Re: Nottingham Hills Subdivision Phase 5

J.P. Mereen is forwarding you revised plans that address your plan review dated 5 November 2021, Ex. A. We have made the following changes to the plans;

EXHIBIT A

Date: 5 November 2021
To: Kristen Clarke, PE; John Paul Mereen, LS
Subject Property: 121 Upper Pattagansett Rd. E. Lyme

GST™ 62" LEACHING SYSTEM

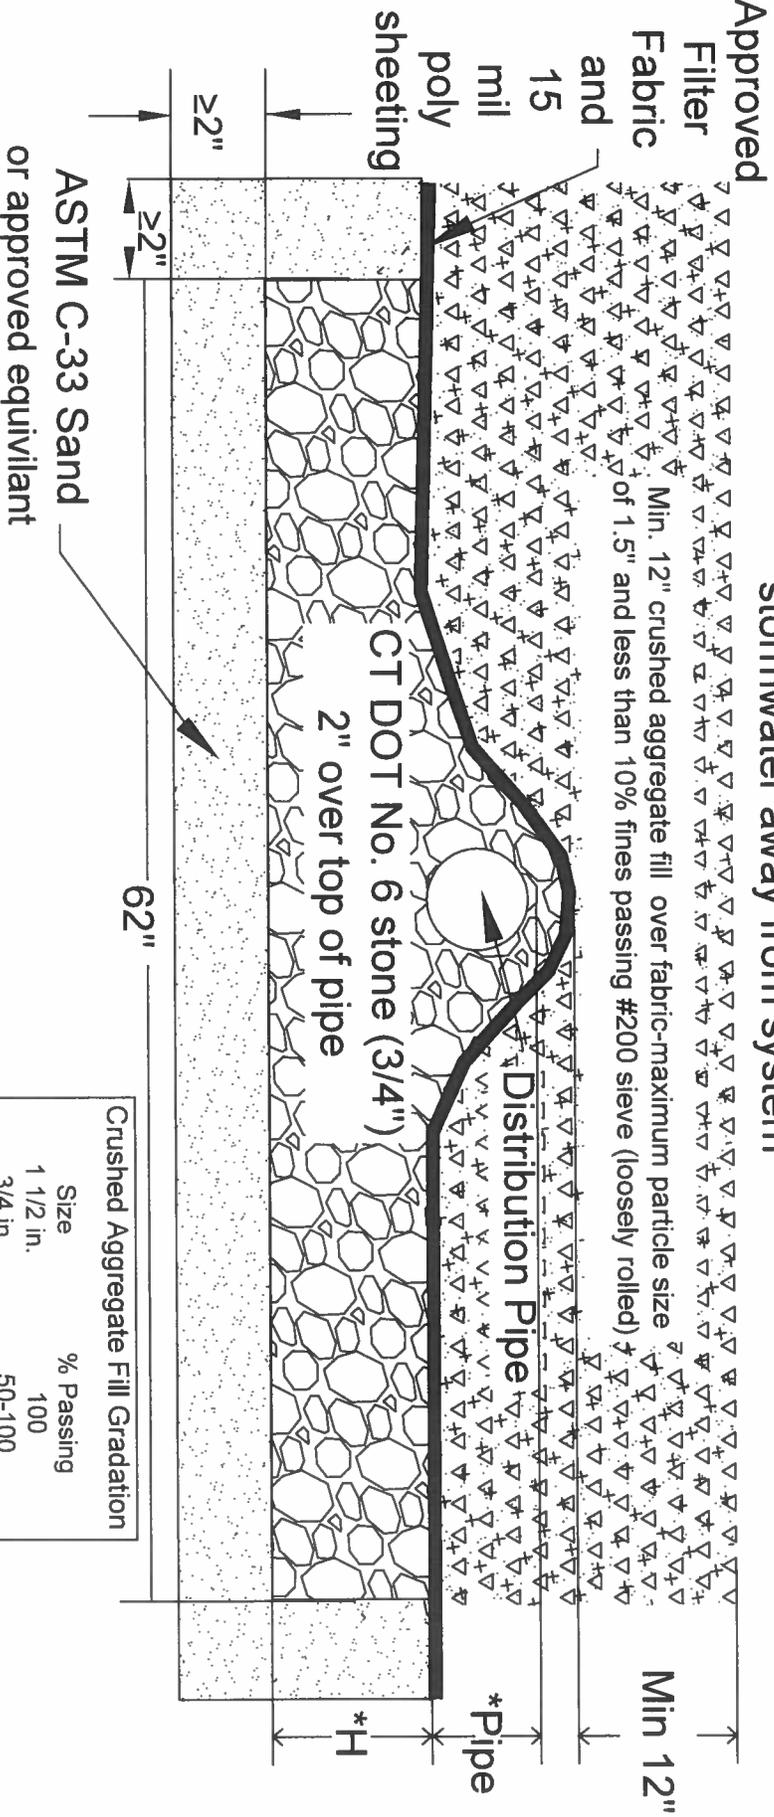
- 1) We have reduced the width of the leaching trenches to 62" per the Geomatrix GST System specifications which I have attached as Ex. B.
- 2) With regard to Lot 52 by using the GST trench sizing we have established more than 25' of separation from the proposed foundation to the leaching trench.
